Appendix E3
Response to Public Comments
Received on DDR/EA

This appendix contains the responses to substantive comments received on the Draft Design Report/Environmental Assessment (DDR/EA) for the NYS Route 33 Kensington Expressway Project. The public comment period for the DDR/EA began on September 12, 2023 and was originally scheduled to conclude on October 27, 2023 (45 days total). Based on the level of public interest and to afford the public more time to submit comments, the New State Department of Transportation (NYSDOT) extended the comment period to November 10, 2023 (59 days total). The NYSDOT also considered comments received after the end of the formal comment period. Between September 12, 2023 and November 10, 2023, approximately 1,312 comments were received via email, the project website, comment forms, oral comments at the September 27, 2023 Public Hearing, and U.S. mail. Between November 11, 2023 and January 10, 2024, an additional 287 comments were received.

Photo 1: Mature trees growing in three feet of soil on pier deck at Hoboken Riverside Park, New Jersey

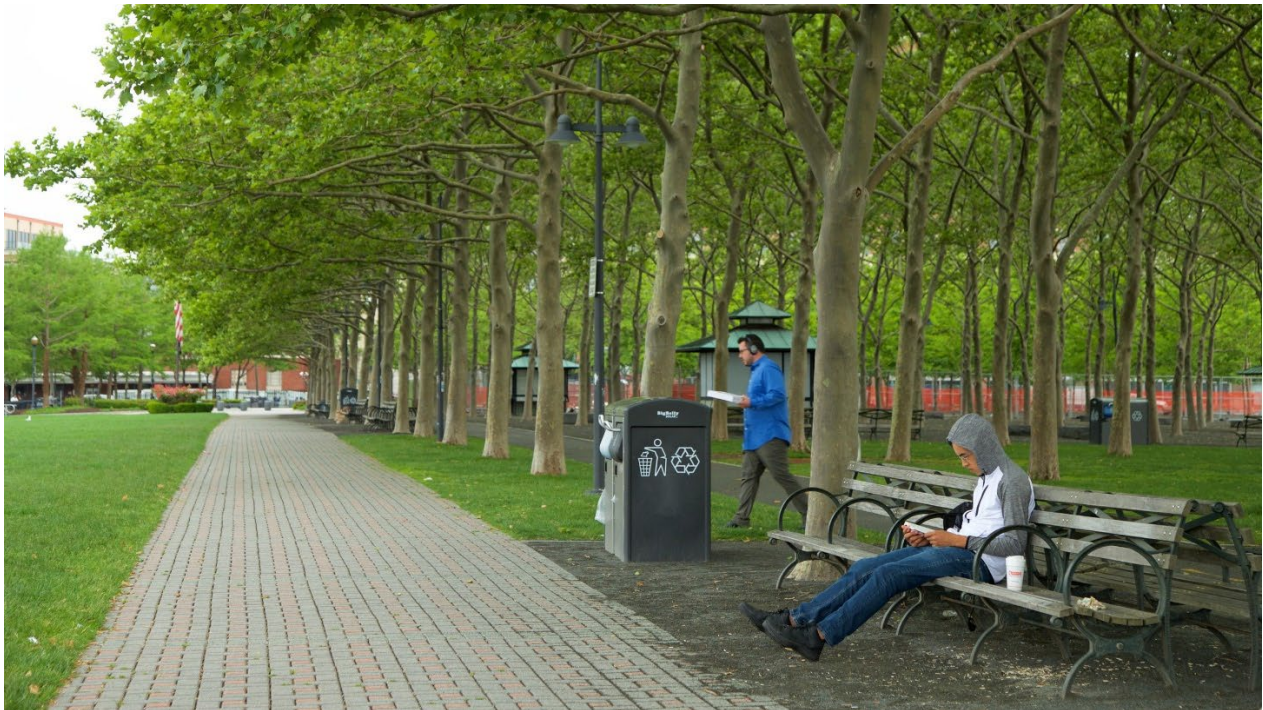
C3.1-3 Commenters stated that the proposed depth of soil on the tunnel deck (three feet) would be inadequate for trees. Commenters stated that greater than three feet of soil depth should be provided so roots can grow deeper and allow for large shade trees to grow. A commenter noted that a highway cap project in Seattle has full size trees and 14-foot deep planters.

R3.1-3 The three-foot minimum soil depth was determined by a registered landscape architect based on experience and a literature review of the soil needs of trees reaching up to 50 feet in height at maturity, see Section 3.4.4.1 of this FDR/EA. The recommended tree species shown on the landscaping plans in Appendix A1 of this FDR/EA involve the use of trees that have lateral (spreading) or oblique root systems. Lateral or oblique root systems grow horizontally, and 80 percent of the tree's roots are in the top 18 to 24 inches of soil. The recommended tree species have been reviewed and approved by the City of Buffalo Department of Parks and Recreation and the Buffalo Olmsted Parks Conservancy.

Similar soil depths to the three feet proposed have led to successful tree development on other projects. One example is the Hoboken Waterfront Redevelopment project, which involved three feet of soil for trees over drainage/insulation layers on pier deck park. The project was completed in the 1990's and successful mature tree plantings have been established (image below).
